Model: Gim-P1a		Date: 23-Feb-15	No.: RM171002
Subject: Service manual revision		Prepared by: T.Suzuki	
From: 3rd Tech. Support Sec. Service Support Dept.,			
Classification:	<input type="checkbox"/> Troubleshooting	<input type="checkbox"/> Part information	<input type="checkbox"/> Action required
	<input type="checkbox"/> Mechanical	<input type="checkbox"/> Electrical	<input checked="" type="checkbox"/> Service manual revision
	<input type="checkbox"/> Paper path	<input type="checkbox"/> Transmit/receive	<input type="checkbox"/> Retrofit information
	<input type="checkbox"/> Product Safety	<input type="checkbox"/> Other ()	<input type="checkbox"/> Tier 2

Subject: Dirty reverse side of printing sheets		Prepared by: J.Kitagawa	
From: 1st Tech Service Sect., MFP/P Tech Service Dept.			
Classification:	<input type="checkbox"/> Troubleshooting <input type="checkbox"/> Mechanical <input type="checkbox"/> Paper path <input type="checkbox"/> Product Safety	<input checked="" type="checkbox"/> Part information <input type="checkbox"/> Electrical <input type="checkbox"/> Transmit/receive <input type="checkbox"/> Other ()	<input type="checkbox"/> Action required <input type="checkbox"/> Servi

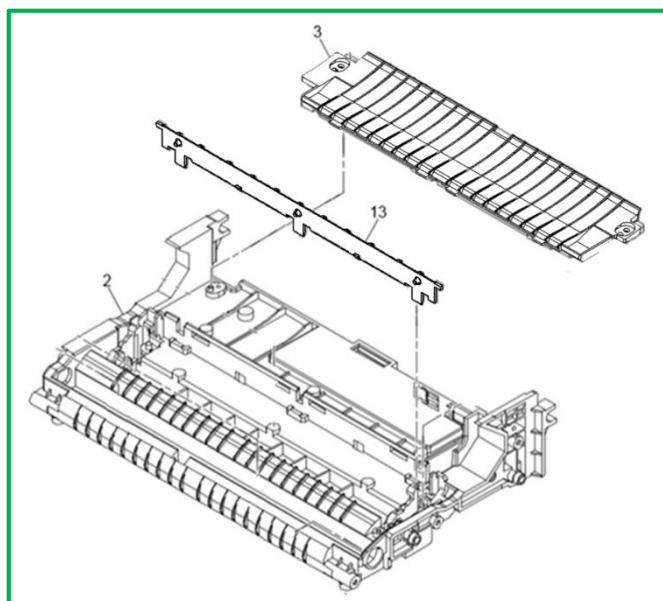
Change: The shapes and/or material of the following parts were changed.

1. The maximum height of the guide rib of the exit guide stay was shortened.
2. The material and shape of the electrode plate cover was changed.
3. The shape of the transfer stay was changed as shown in the illustration.

Reason: To further minimize staining on the printed paper.

Note: The reverse side of the printed sheets may get dirty when the sheets pass through the area indicated in the illustration.

Important: These three parts need to be installed **together as a set**.

Old

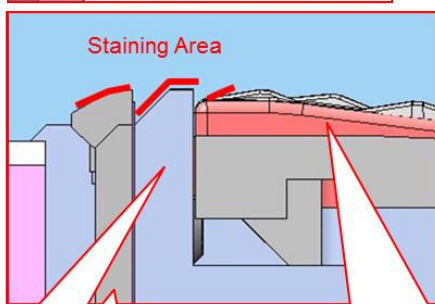
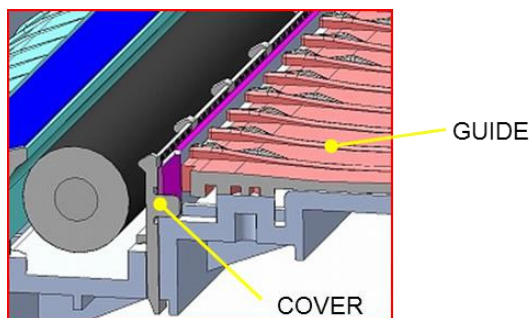
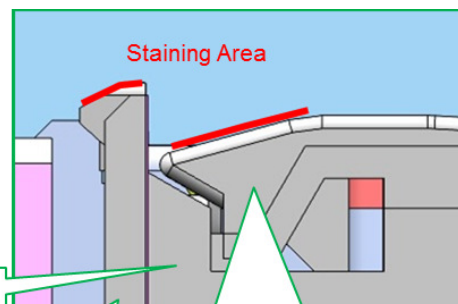
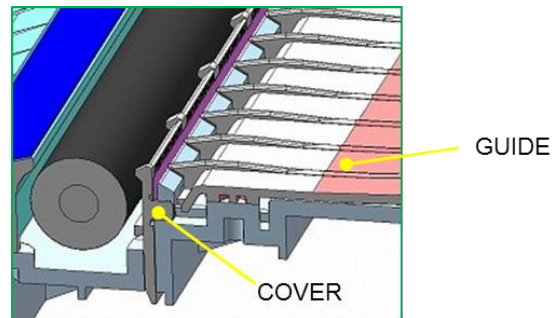
M1603850
STAY:TRANSFER

M1603851
GUIDE:EXIT:STAY:TRANSFER

M1603861
COVER:ELECTRODE PLATE:SEPARATION

M1603870
STAY:TRANSFER

M1603866
GUIDE:EXIT:STAY:TRANSFER:2

M1603865
COVER:ELECTRODE PLATE:SEPARATION:2

2. Operation Panel

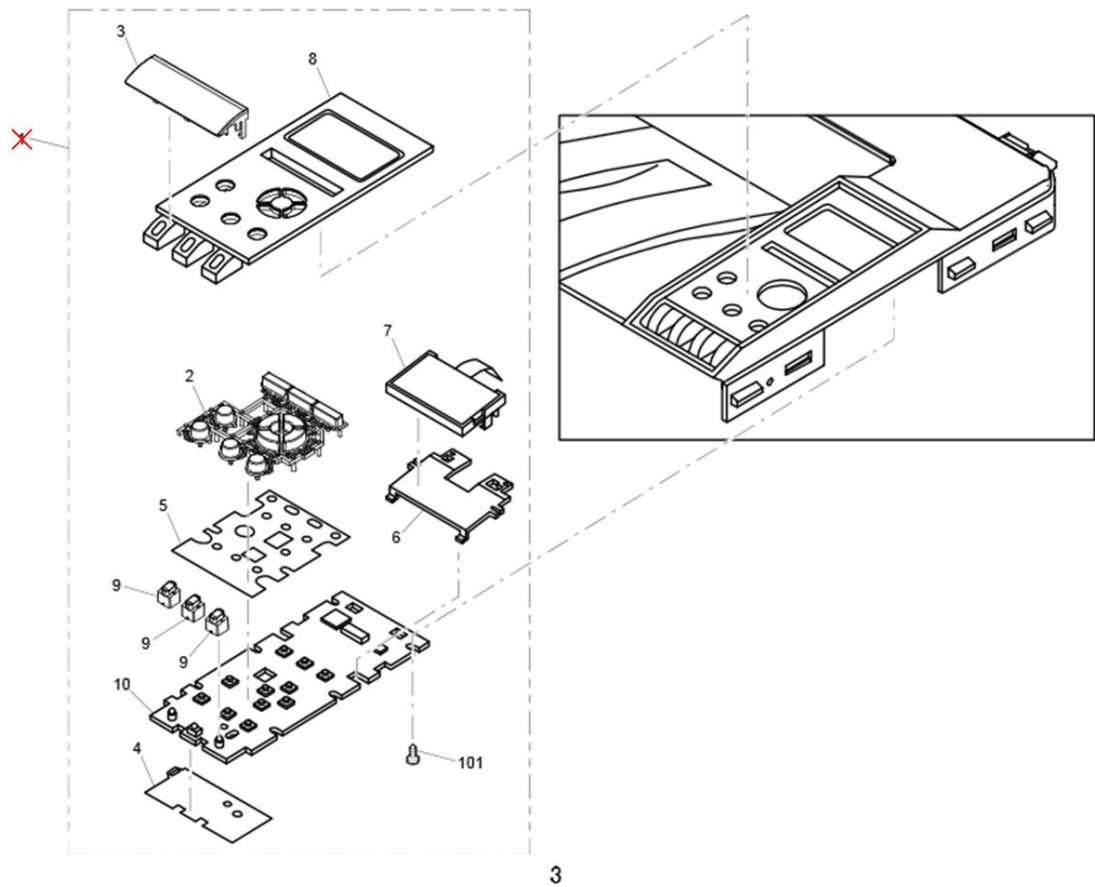
Change: The following part was deleted. Instead, the components are available as individual service parts.

Reason: Difficulty in supplying the operational panel as an assembled unit.

Note: The individual parts (indexes 2-10, 101) are still available.

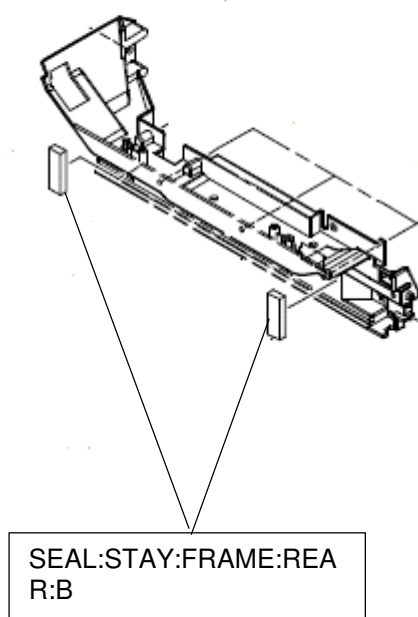
Change/Reason: The part number was missing from the Parts Catalogue.

LED Lever Operate Decal

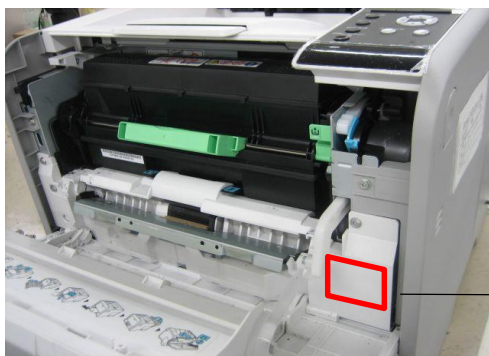
Change: An instructional decal for the LED lever was added.

Reason: To facilitate easier operation of the LED lever.

10. Fusing Section 1

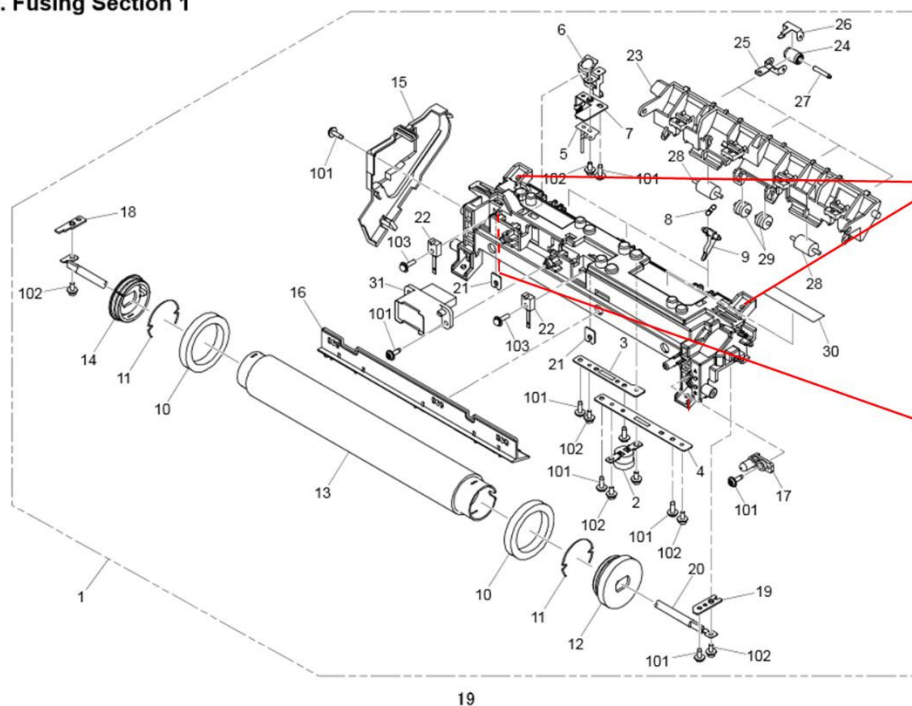
Change: Geometry of these parts has changed.

Index No.34
M1604141
WASHER:DIA10.1:DIA6.0:0.6T

Index No.32
M1604138
GROUND PLATE:HOT ROLLER

Index No.33
M1604139
RESISTOR:1GOHM

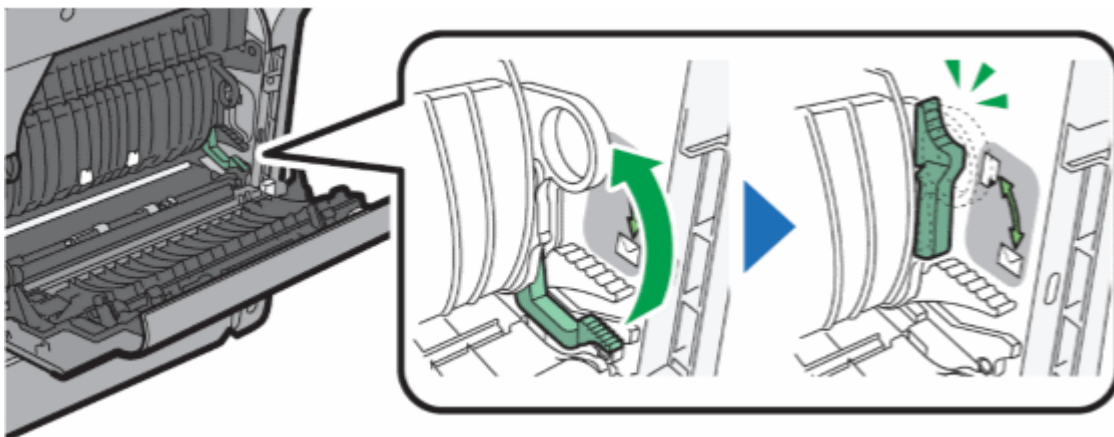
Toner is not properly fixed when printed on a recommended type of plain paper.

The lever is set to the low position for envelope printing.

Raise the lever to the high position.

Lower this lever only when printing on envelopes.

After installing the device or replacing the fusing unit, make sure to raise the lever.

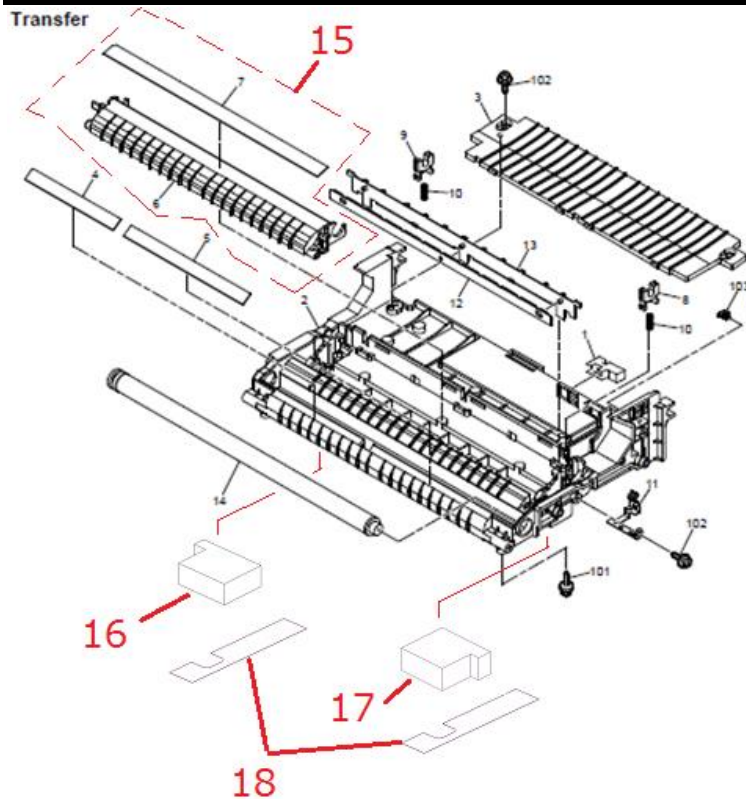
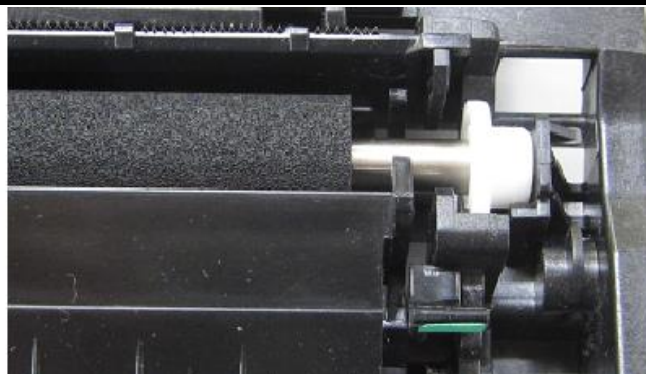
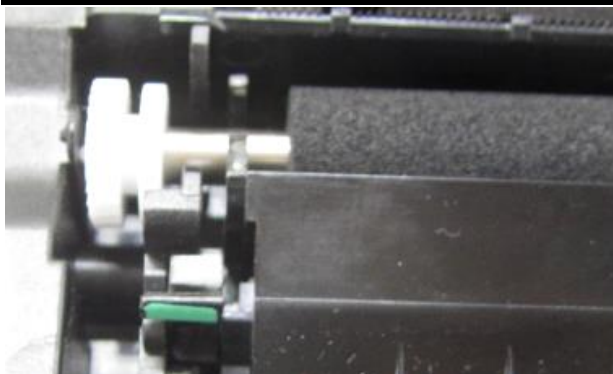
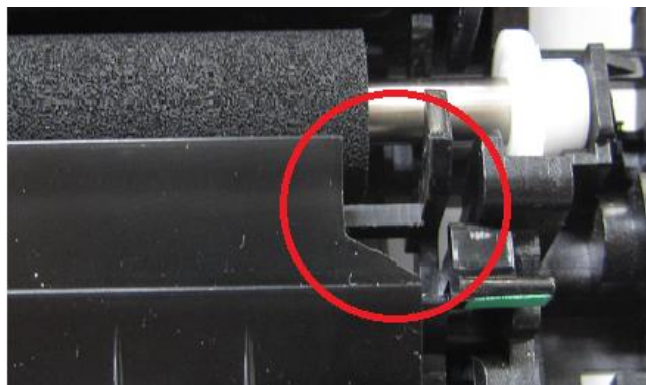
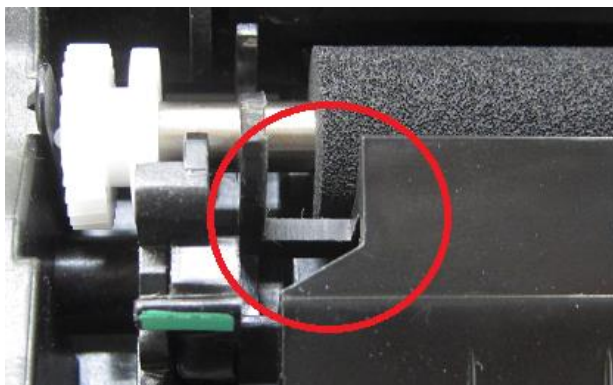
- A cut-out was applied to the right and left edges of the front paper guide of the transfer roller.
- Sponges and sheets were added to the transfer stay.

To avoid black band stains caused by dropped toner on the front paper guide of the transfer roller.

With this modification, dropped toner goes around the right and left edges of the front paper guide and accumulates on the transfer stay.

This modification has compatibilities. Since the old transfer stay cannot be replaced in the field and the stay of the old type is compatible only with the front paper guide of the old type, when replacing the front paper guide of an old machine, make sure to procure the old type.

21. Main Frame Section

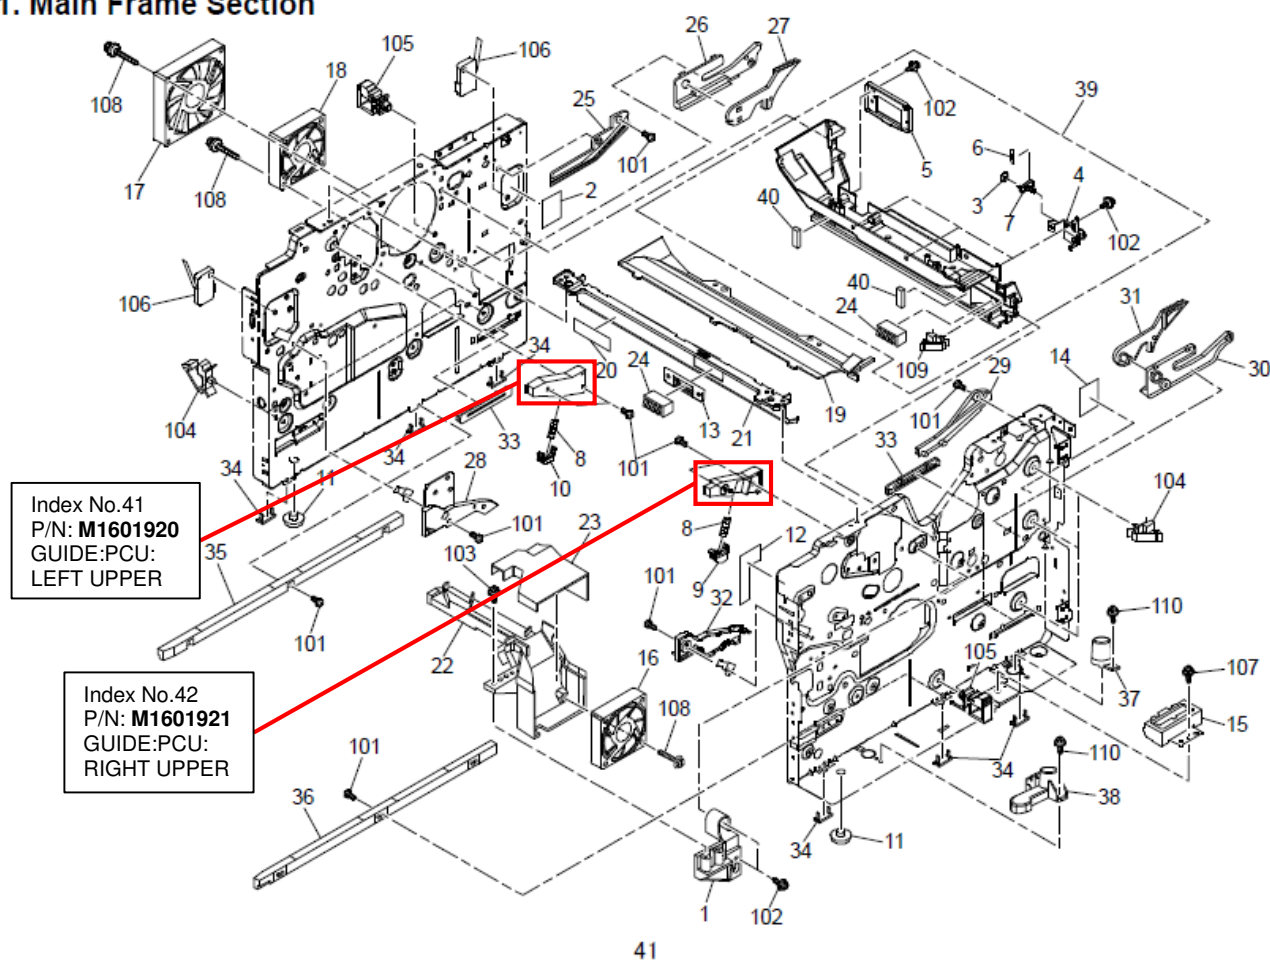
The following parts were registered as service parts.

1. Exterior

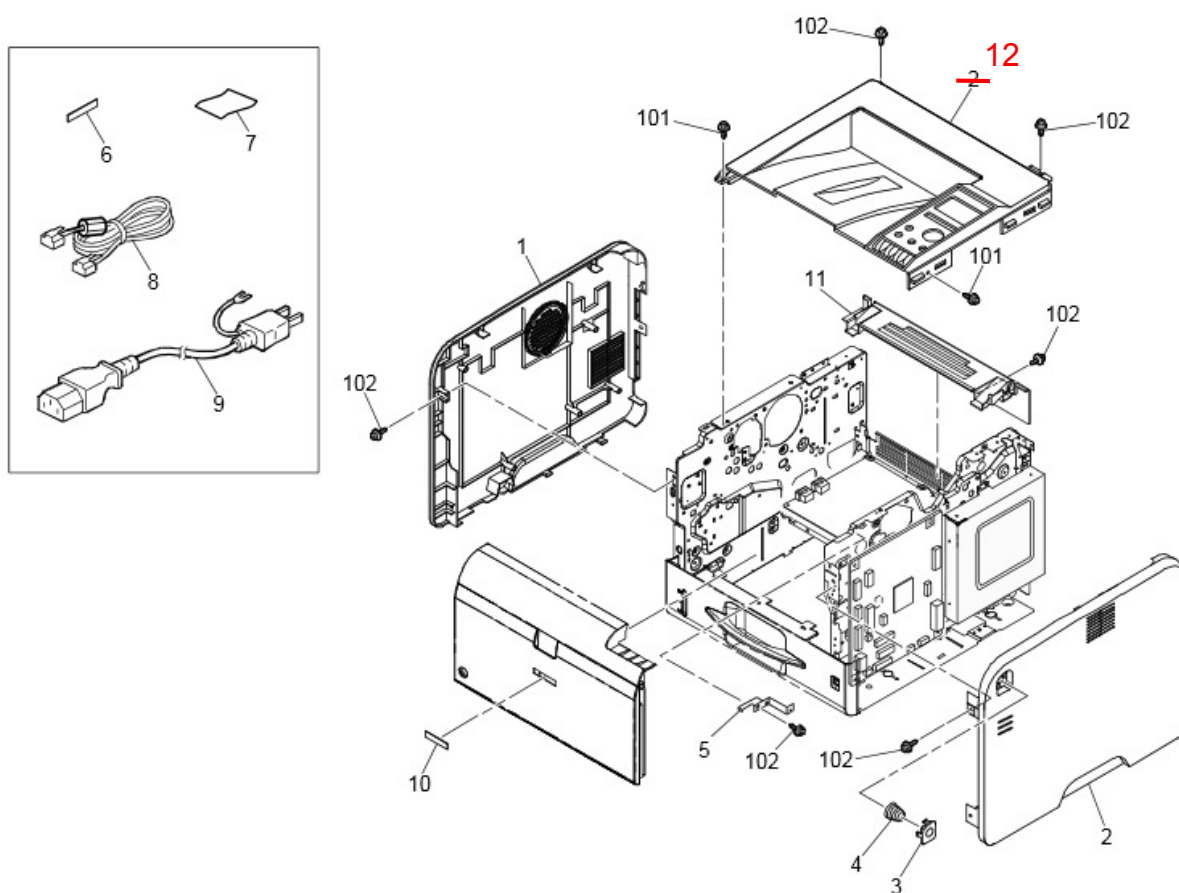
Part number of the upper cover was missing from the parts catalog and its index number was incorrect. Please make the following correction to your part catalog.

16. Electrical Components Section

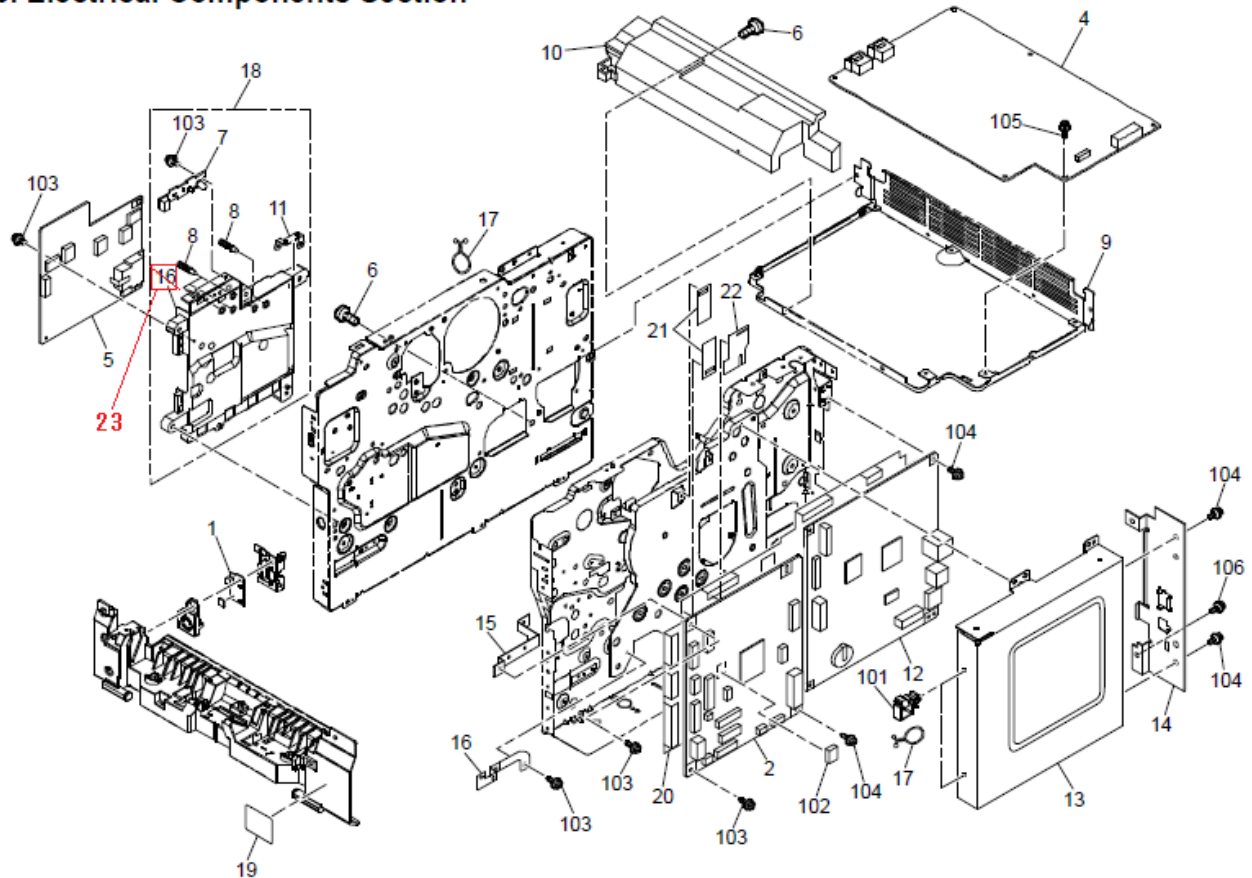
Change: The following part numbers were corrected.

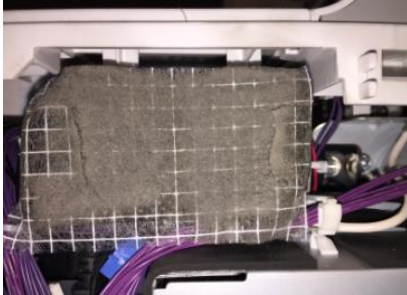
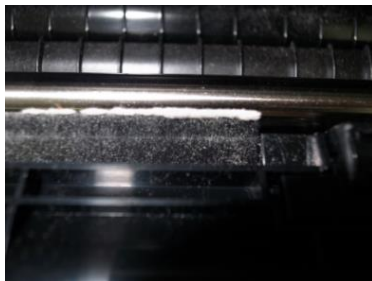
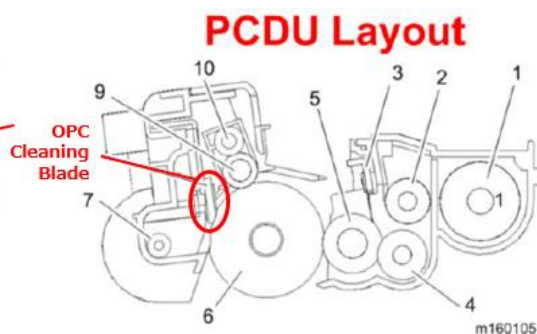
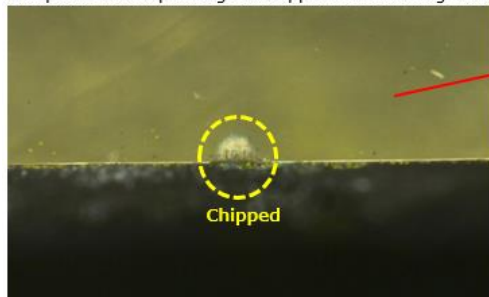
1. *A foreign substance enters the machine via the intake fan.*

2. *Paper dust accumulates inside the paper path.*

Paper dust or other foreign substance adheres to the drum, gets caught between the drum and cleaning blade, and/or chips the surface of the blade.

At such a location, the cleaning blade cannot clean toner out from the PCDU, causing a black line on prints. Gradually the unremoved toner transfers to the charge roller and charge cleaning roller. When it comes to a certain level, the charge roller cannot charge sufficiently, causing a white line on prints.

Inside of the right cover:

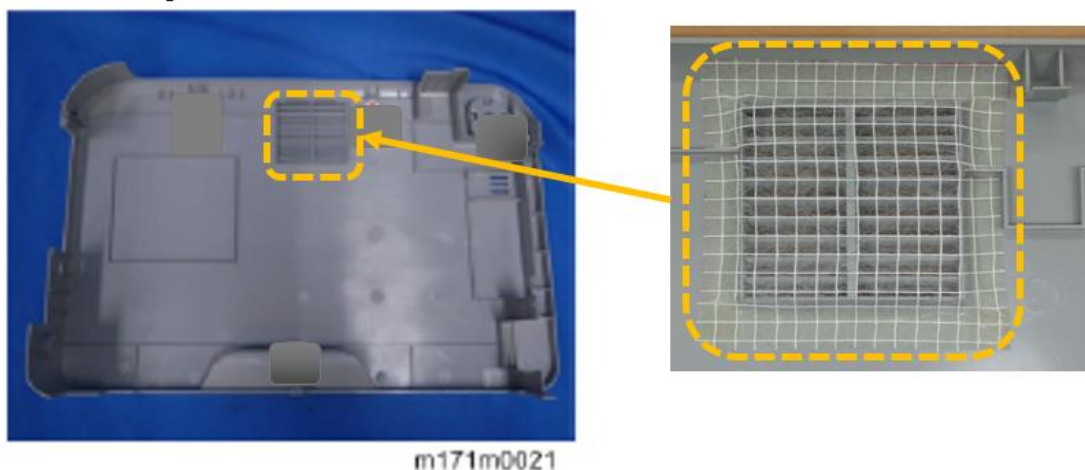
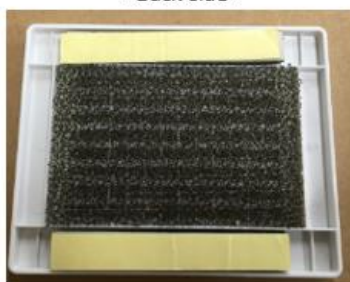
A filter sheet is added to prevent the entry of abnormal substances coming from the intake fan.

Sample: microscope image of chipped OPC cleaning blade

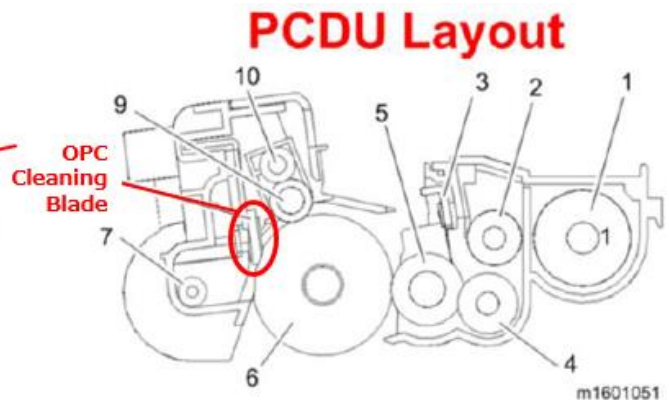
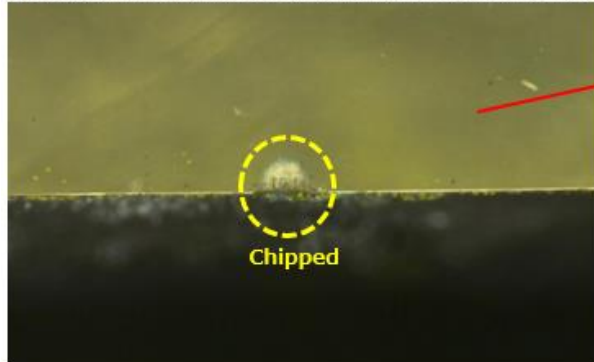
Abnormal substance comes inside from the intake fan, then it adheres on the drum. Then the abnormal substance which adheres to the drum is caught and/or chips the cleaning blade.

At such a location, the cleaning blade cannot clean toner out from the PCDU, causing black lines on prints. Gradually this toner transfers to the charge roller and charge cleaning roller. When it comes to a certain level, the charge roller cannot charge sufficiently, causing white lines on prints.
